SERVICE BULLETIN

ENGINE — PACKING, PREFORMED — REPLACEMENT OF THE NO. 3 BEARING SEAL SUPPORT
PREFORMED PACKING WITH A SMALLER PREFORMED PACKING TO REDUCE OIL LEAKAGE

V2500 Series 72-0698

V2500-ENG-72-0698

LOCATION OF THE PREFORMED PACKING
72-32-20
FIGURE 1

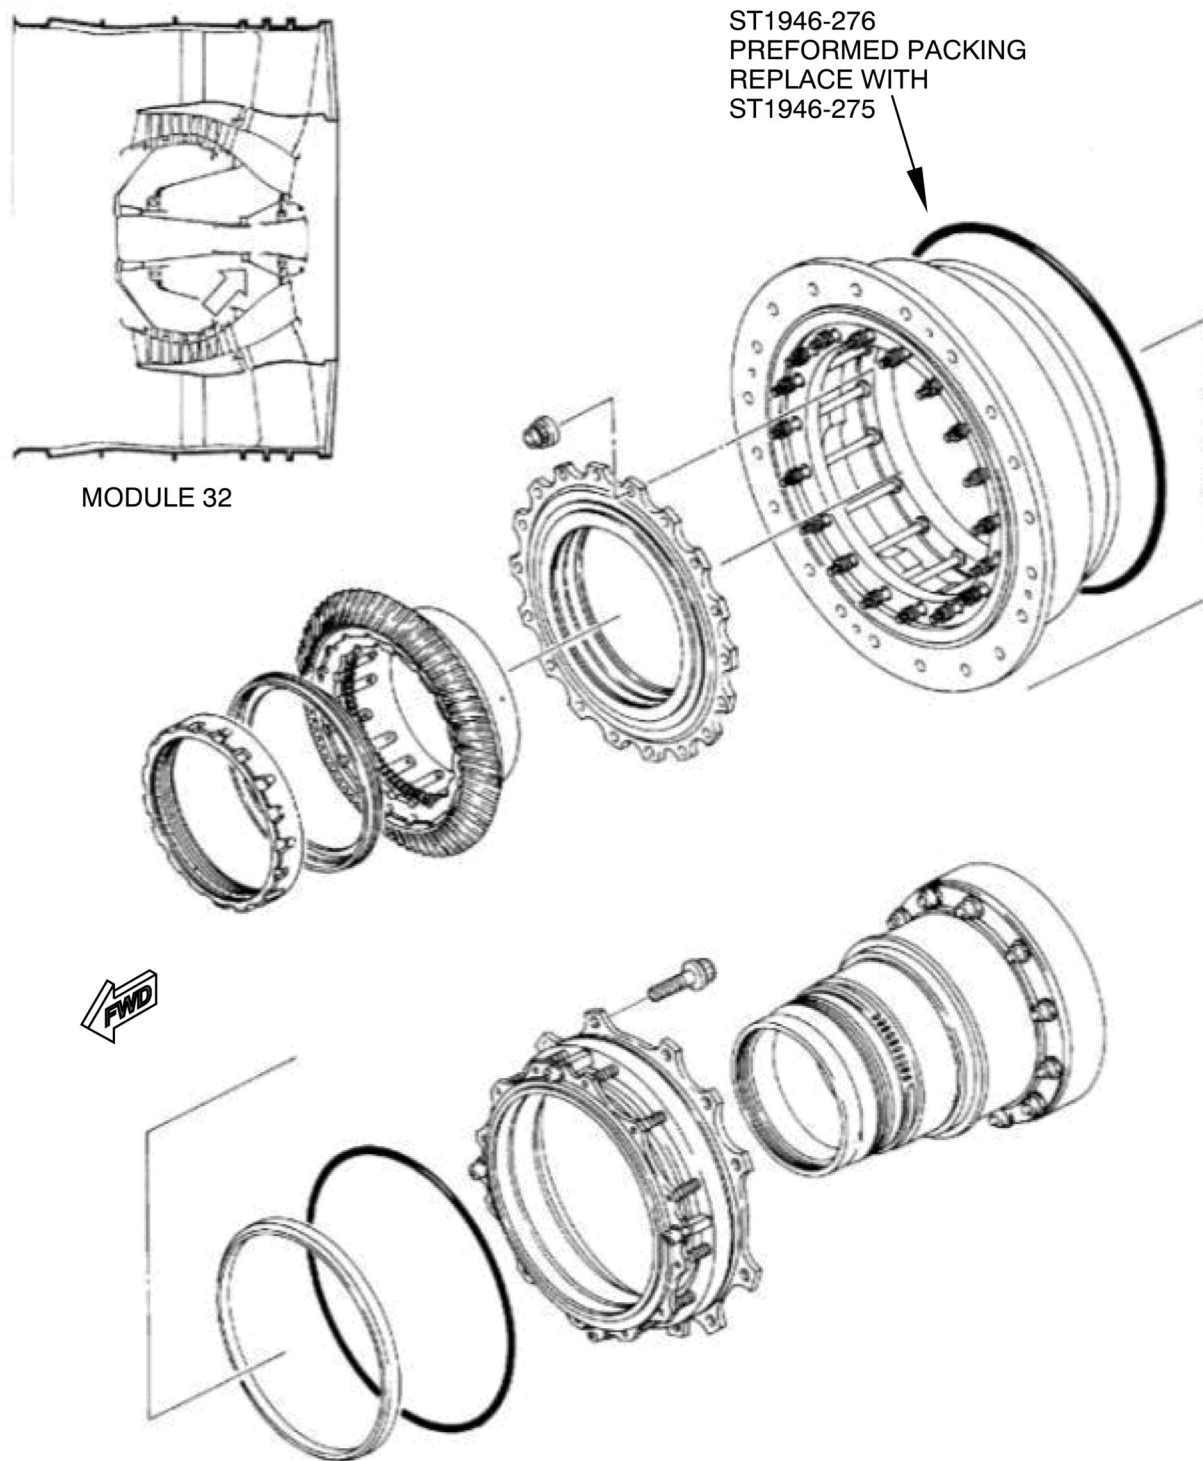
1. Replace the Preformed Packing, PN ST1946-276 with PN ST1946-275. See Figure 1.
2. Recording Instructions
 - A. A record of accomplishment is required.
